APPENDIX A

INTERAGENCY COORDINATION AND CORRESPONDENCE

Re: Project review under Section 106 of the National Historic Preservation Act of 1966, DOPAA:
Sediment Removal Downstream of Retamal Diversion Dam, Hidalgo County, Texas (IBWC)

D-14828
 Location Map
 International Boundary and
 Water Commission
 Rio Grande River
 Hidalgo County, Texas
 Page 1 of 1
 18 June 2003

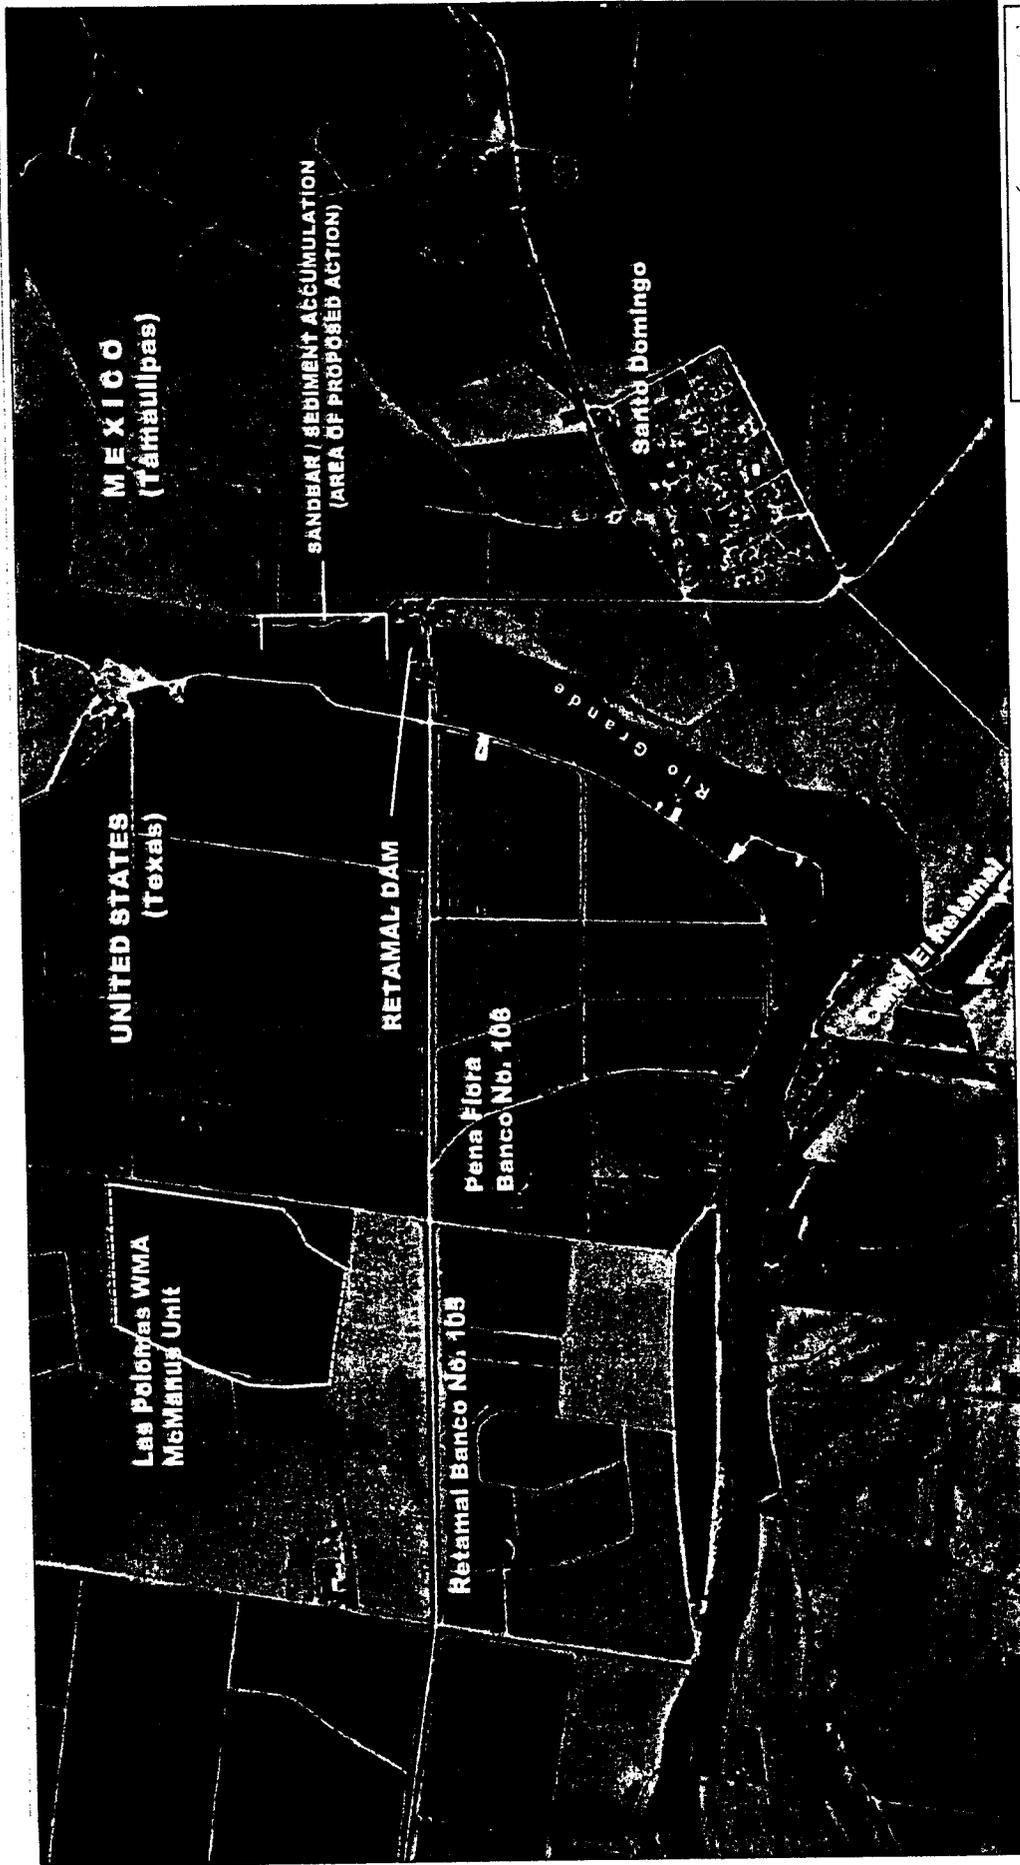
This concerns a letter, dated May 9, 2003, submitted on your behalf by Parsons, requesting comments on the proposed removal of a island and sandbar from the Rio Grande River as shown on the enclosed plan in one sheet. The project site is located downstream of the Retamal Diversion Dam in the Lower Rio Grande Flood Control Project, 8 miles south of Weslaco, Hidalgo County, Texas.

According to the information that was submitted by Parsons, a vegetated island and sand bar will be removed from the Rio Grande River by hydraulic dredging. Approximately 54,000 cubic yards of material will be dredged and placed in temporary dewatering cells along the Mexican riverbank. The material will eventually be removed from the cells and taken to a permanent disposal area in Mexico. The Rio Grande River is a navigable water of the United States and is regulated by the Corps of Engineers under Section 10 of the Rivers and Harbors Act and Section 404 of the Clean Water Act. Under Sections 10 and 404, activities that involve work in waters of the United States, including the discharge of dredged and/or fill material, require a Department of the Army (DA) permit. The proposed removal of the sandbar will require a DA permit under Section 10; however, as long as all the excavated material will be placed in Mexico there will not be a requirement to review the permit under Section 404 of the Clean Water Act. Mitigation will probably be necessary to compensate for those impacts to wetlands located on or adjacent to the island and sandbar. Once project specific plans are available, you should contact us for additional information regarding the permitting process.
